HYDROLOGY

4 PLEXES FOR 3RD CENTURY HOMES
129, 133, 137, 141 MANZANO ST NE. ALBUQUERQUE N.M.

GRADING & DRAINAGE PLAN

VOID - SEE REVISED SHEET #2 DATED 8-21-81 ATTACHED HERETO — TOP

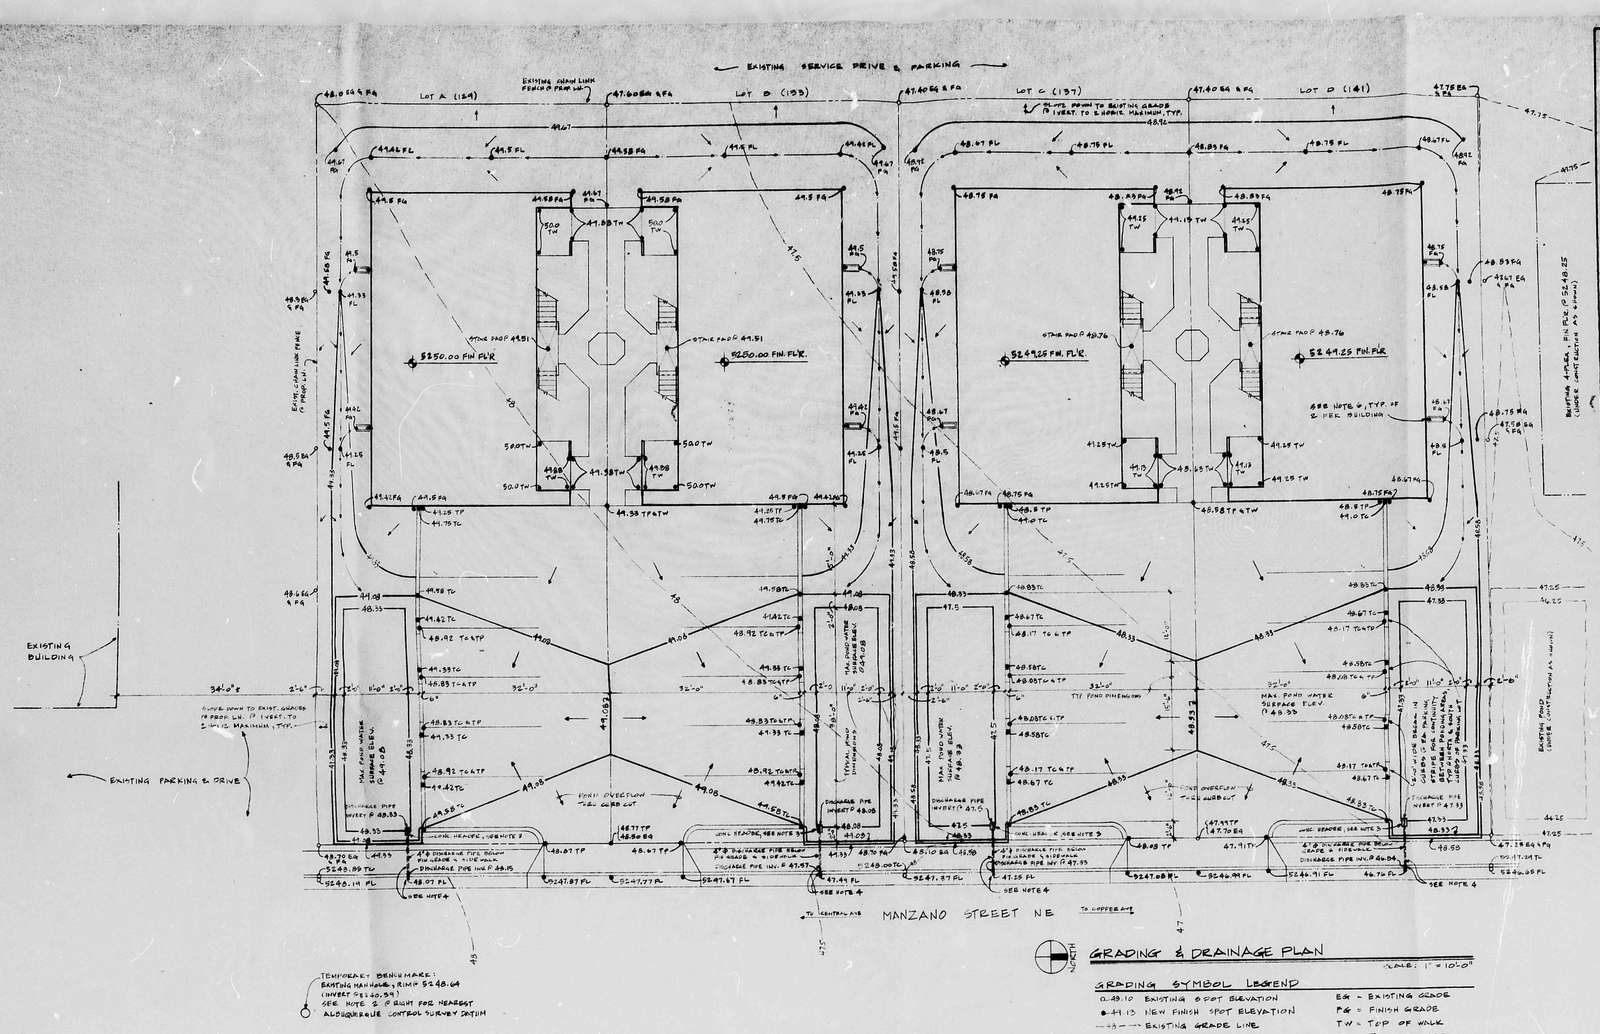
I cannot verify. If approved that the overflow will take all known the pond because of the equal elevation surrounding the pond.

GRADING & DRAINAGE PLAN

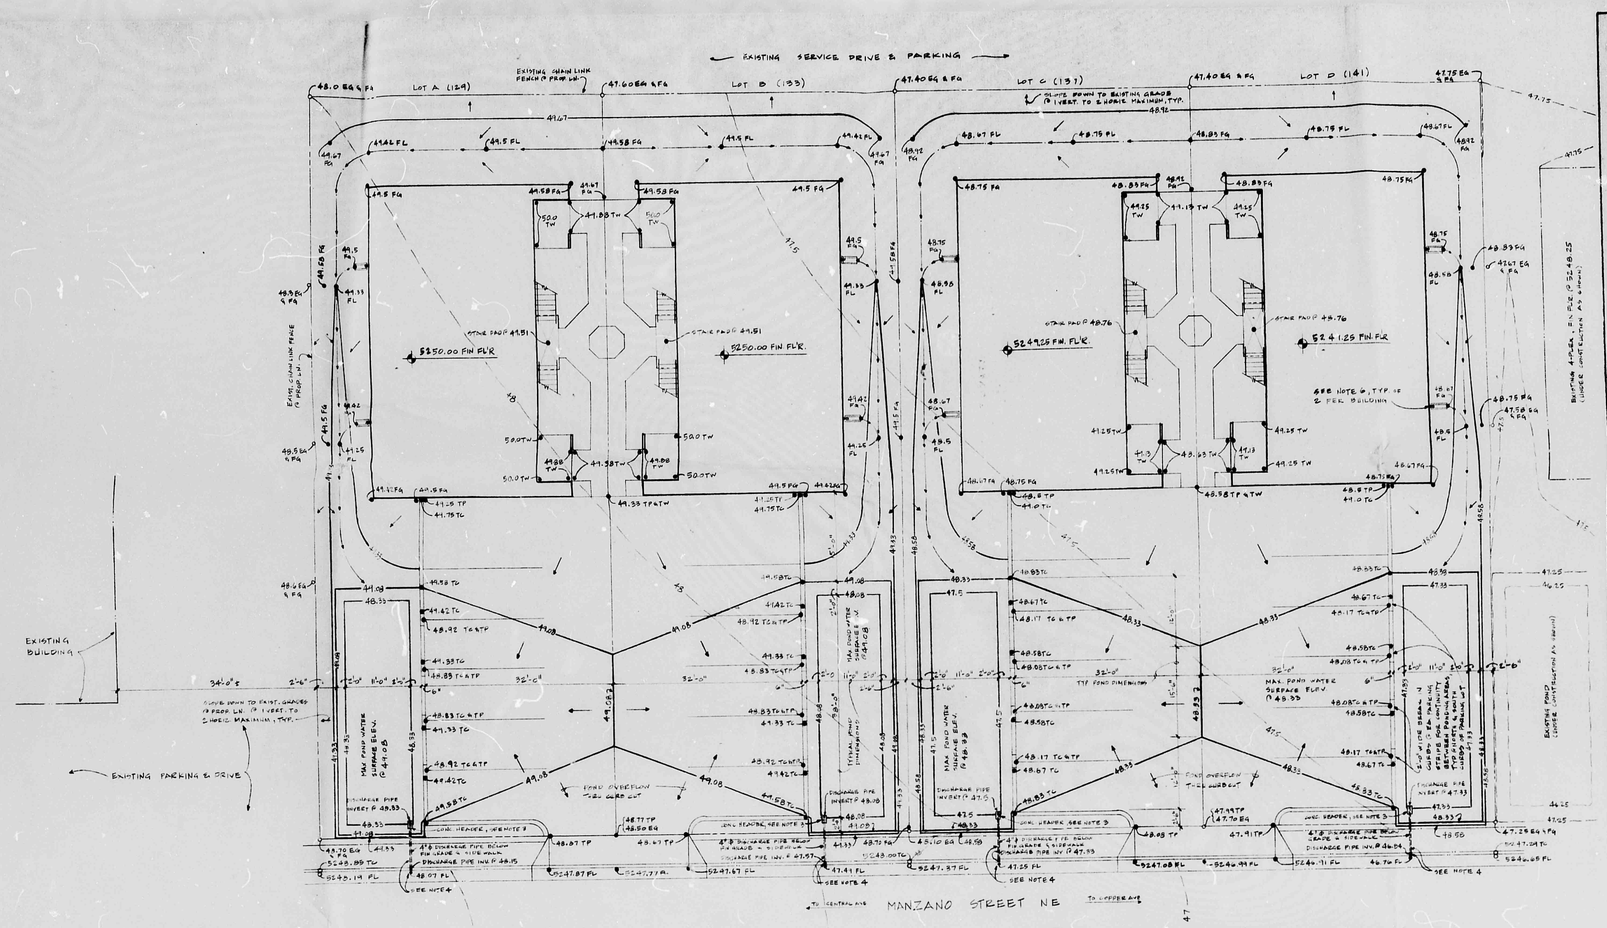
no.	date	revision
1	8-21-81	revised ponding grades, relocated discharge pipes & changed size to 4'-0", added pond max water surface level, erosion control, grading & area drainage per hydrology review requirements

APPROVED FOR DRAINAGE
9-2-81
DATE
ADVISE DRAINAGE INSPECTOR WHEN GRADING IS COMPLETED
(Comment on the letter dated August 27, 1981 to Mr. Stowell.)
